Memorandum

Re: Overlap review for 57-7552

Overlap Review Map 57-7552 and 57-7117

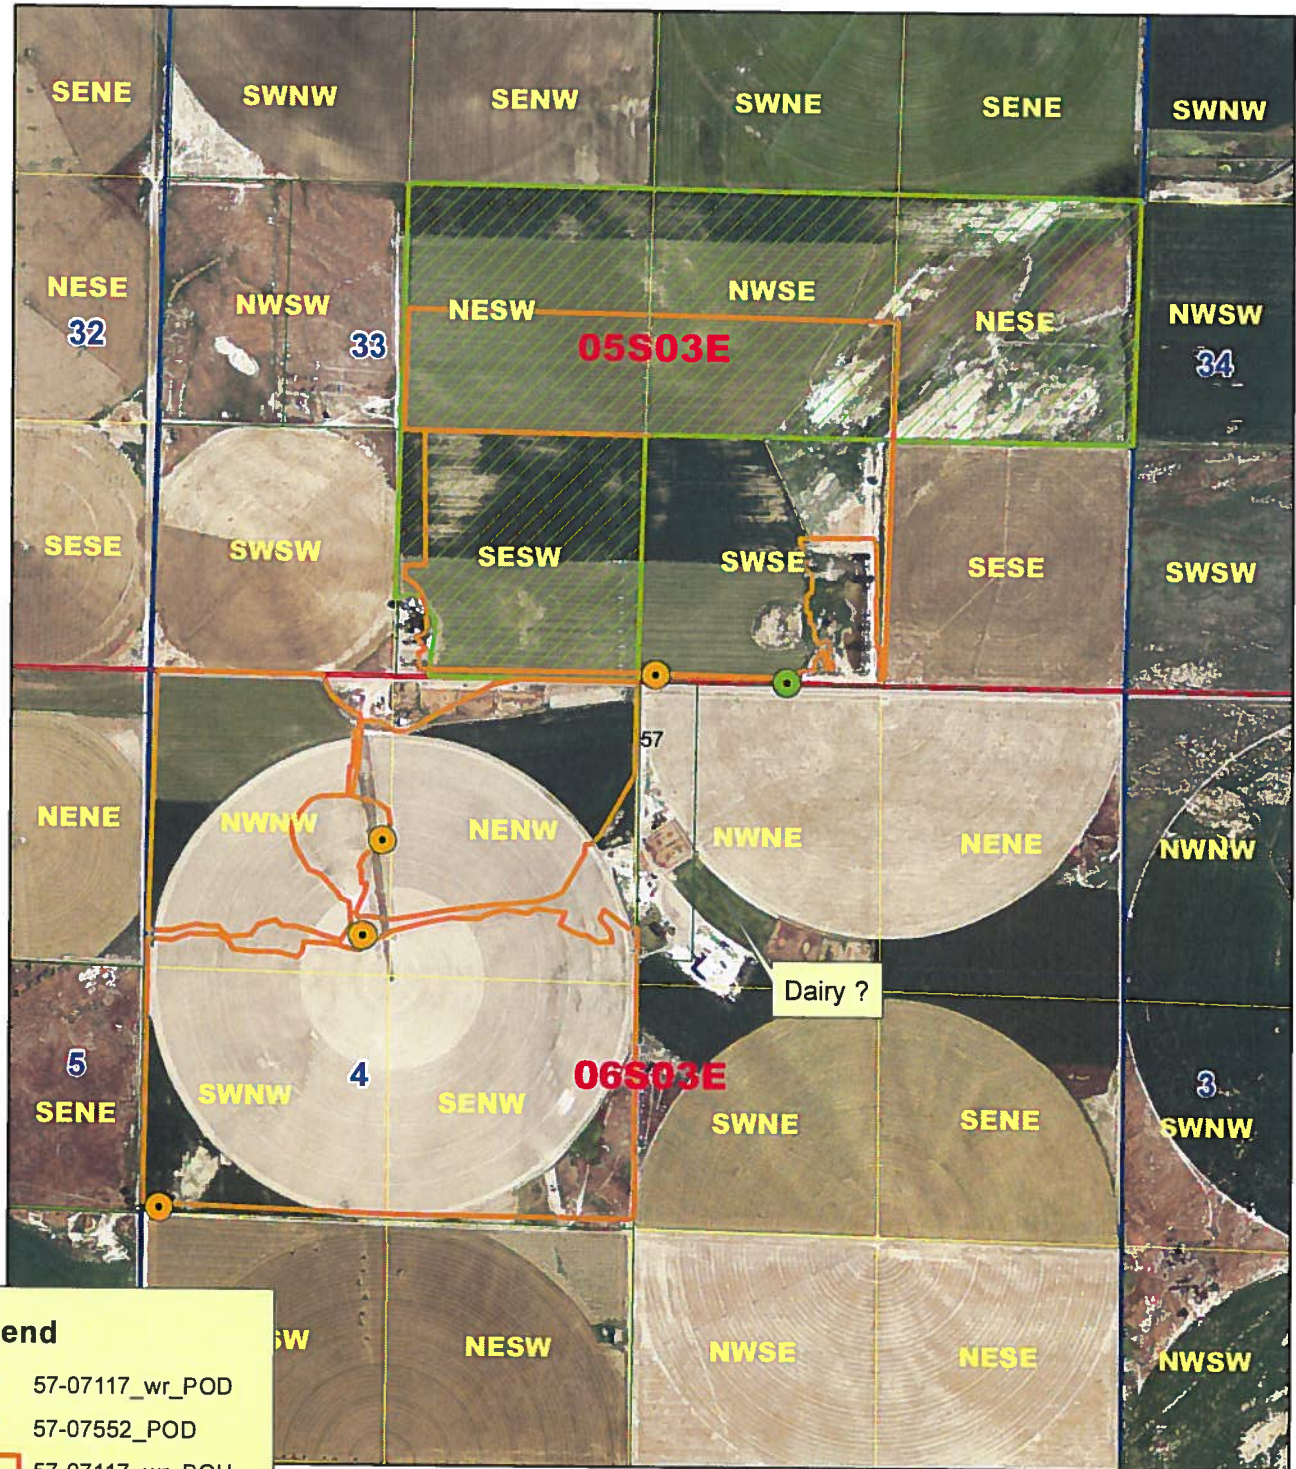
Overlap analysis on the beneficial use field examination report did identify overlap with 57-7117. The narrative identified the overlap consisting of 76 acres. However, addition of a combined use condition should be added to 57-7552 to address that overlap to prevent possible un-stacking or enlargement in the future.

The narrative indicated that the portion of 57-7117 that overlaps 57-7552 is supplemental in nature since it is a groundwater right. However, the groundwater right has an earlier priority date than 57-7552 and there are no supplemental conditions on 57-7117 identifying it as such. I think it is appropriate to add a combine use limit to 57-7552.

I suggest adding:

X35: Rights 57-7117 and 57-7552 when combined shall not exceed the irrigation of 332 acres.
